Re: Revised Closure Permit Application for the Plant Gorgas Ash Pond

PERMIT APPLICATION FOR CCR SURFACE IMPOUNDMENT

PLANT GORGAS ASH POND

DRAWING TITLE	
MONITORING WELL LOCATION MAP PLANT GORGAS ASH POND	
FIGURE NO	FIGURE 7

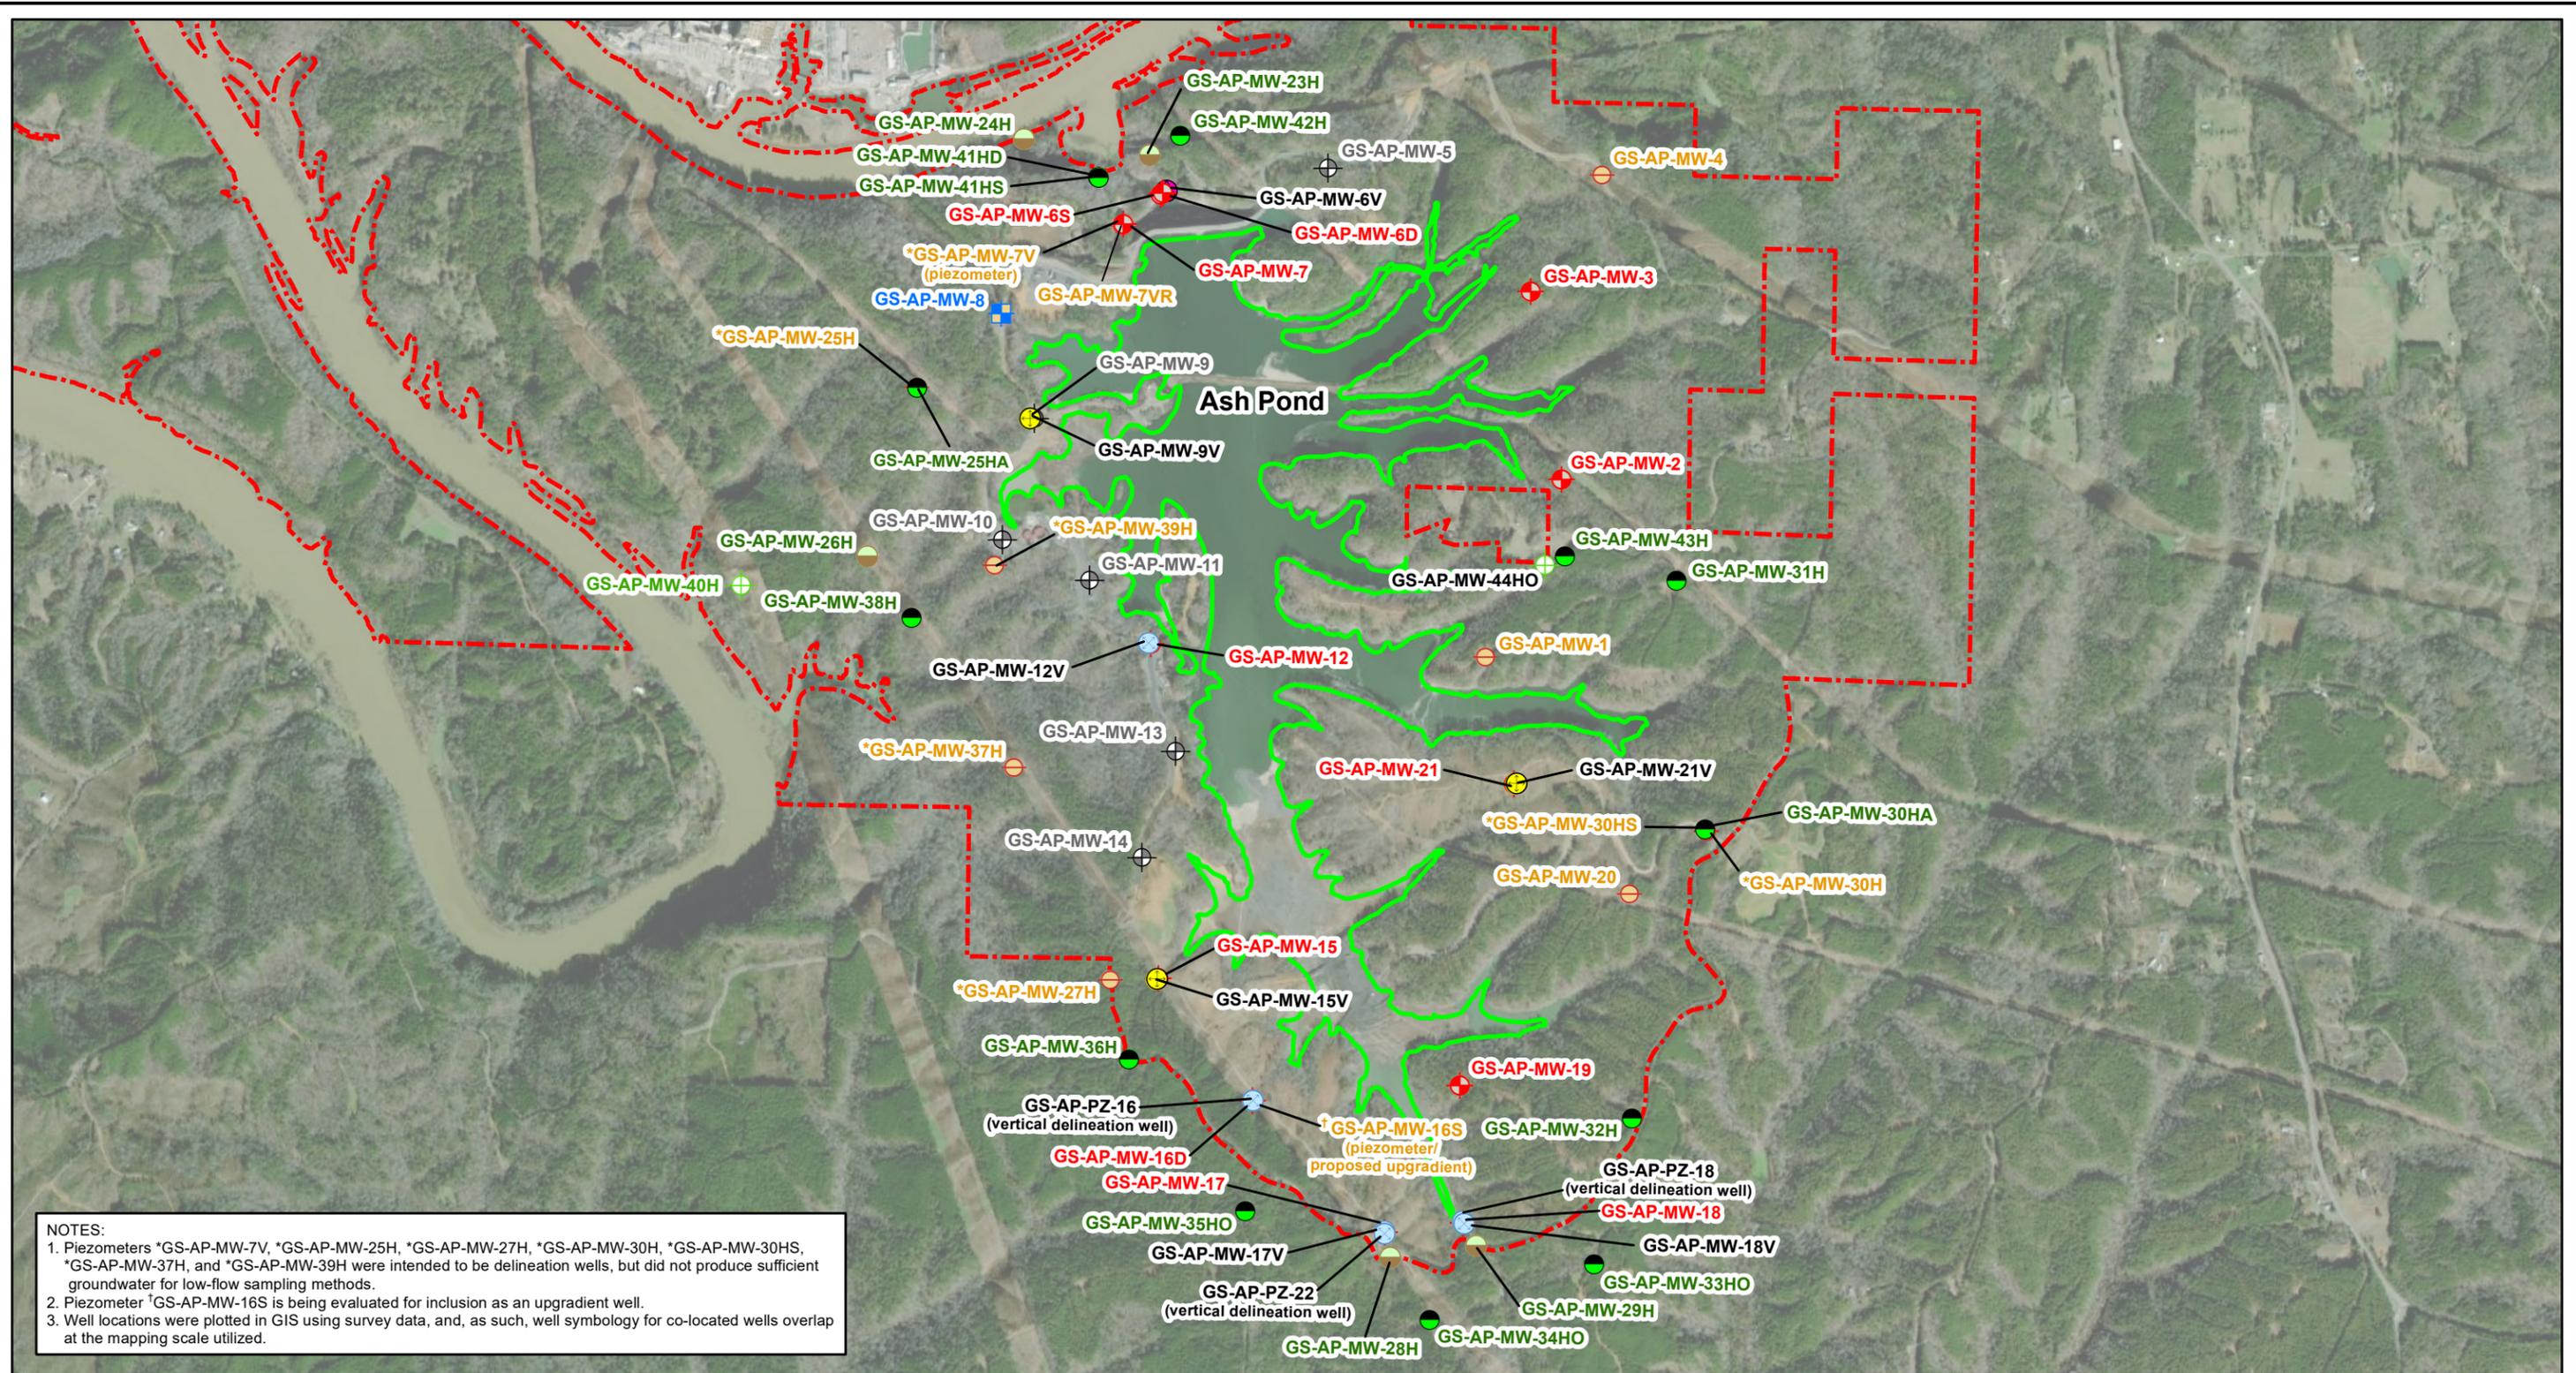
2. *Figure 7 indicates that monitoring wells GS-AP-MW-5, GS-AP-MW-9, GS-AP-MW-10, GS-AP-MW-11, GS-AP-MW-13, and GS-AP-MW-14 have been abandoned. Section 4.3 of the GWMP indicates that a plan for replacing downgradient monitoring wells GS-AP-MW-9, GS-AP-MW-11, and GS-AP-MW-14 will be submitted to the department in the future. Section 4.3 lists GS-AP-MW-13 as a downgradient location. Please clarify the designation of monitoring well GS-AP-MW-13. The replacement of monitoring wells GS-AP-MW-5 and GS-AP-MW-10, and GS-AP-MW-13 should be addressed. The GWMP should specify that an adequate set of replacement wells will be installed to monitor the site.*

GS-AP-MW-13 was abandoned in July 2019 as shown on Figure 7. It was erroneously listed in Section 4.3 as a downgradient location when in fact it is an upgradient background well as identified on Table 2 of the GWMP and in the SAP. Although the well was abandoned, the data from the well remains in the database for statistical analysis.
